## **RANGELINE CROSSING SUBDIVISION**

APPLICATION NUMBER 22 DATE October 3, 2013

REQUEST Subdivision

# DETAIL SITE PLAN

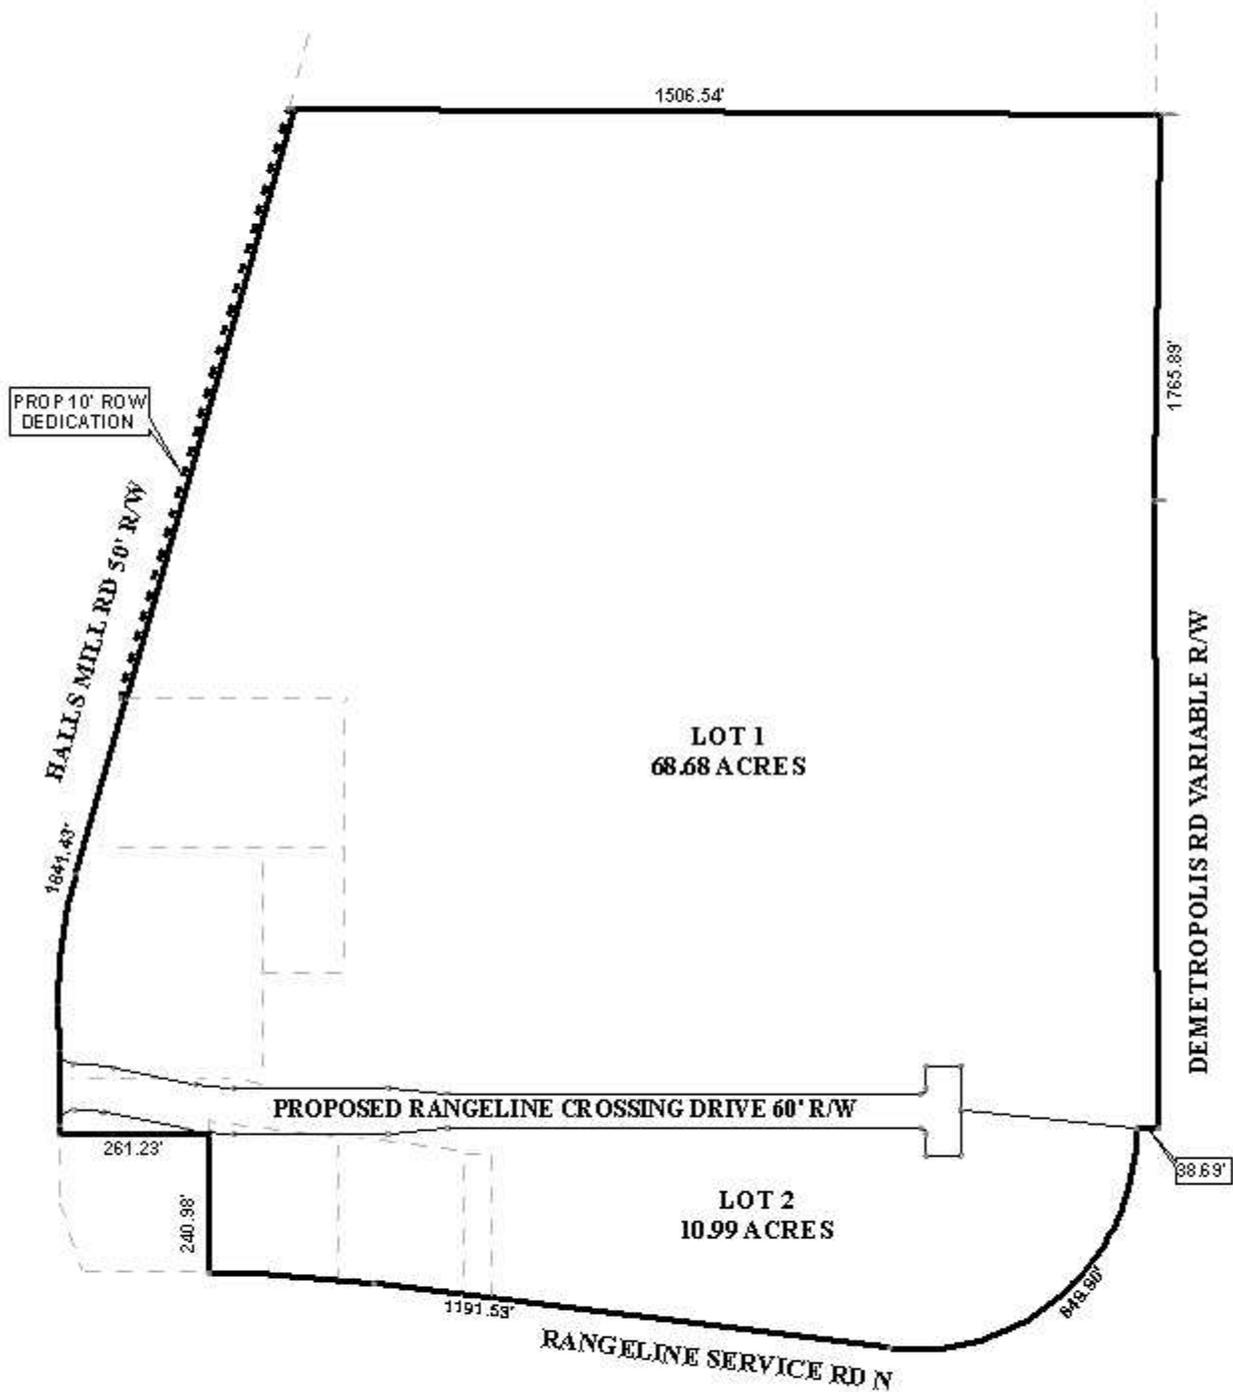
A proposed internal street with a minimum 60' right-of-way is indicated on the plat with a hammerhead terminus. As the street is over 600' in length, a waiver of Section V.B.6. of the Subdivision Regulations would be required. Also, Section V.B.14. of the Subdivision Regulations requires closed-end streets to have a cul-de-sac with a minimum radius of 60' if no center median is proposed. Therefore, the plat should be revised to provide such.

No building setback lines are indicated on the plat. The 25' minimum building setback line should be illustrated along all street frontages as measured from any required right-of-way dedication, and from the proposed internal street.

A common area is indicated at the Halls Mill Road entrance to the internal street. A note should be required on the Final Plat stating that the maintenance of the common area is the responsibility of the property owners.

The recorded plat of Halls Mill Crossing Subdivision indicates an easement in the Southeast corner of the property and extending completely along the East side. This easement should either be illustrated on the Final Plat or vacated prior to the signing of the Final Plat.

- 5) revision of the plat to provide a cul-de-sac with a minimum 60' radius in compliance with Section V.B.14. of the Subdivision Regulations, if no center median is proposed, instead of the hammerhead turn-around on the internal street;

- 6) illustration of the 25' minimum building setback line along all street frontages as measured from any required right-of-way dedication;
- 7) labeling of each lot with its square feet and acres, after any required right-of-way dedication, or the furnishing of a table on the Final Plat providing the same information;

- 8) placement of a note on the Final Plat stating that the maintenance of the common area is the responsibility of the property owners;
- 9) illustration of the existing recorded easement in the Southeast corner of the property, extending along its East side, or vacation of this easement, or portions thereof, prior to signing the Final Plat;
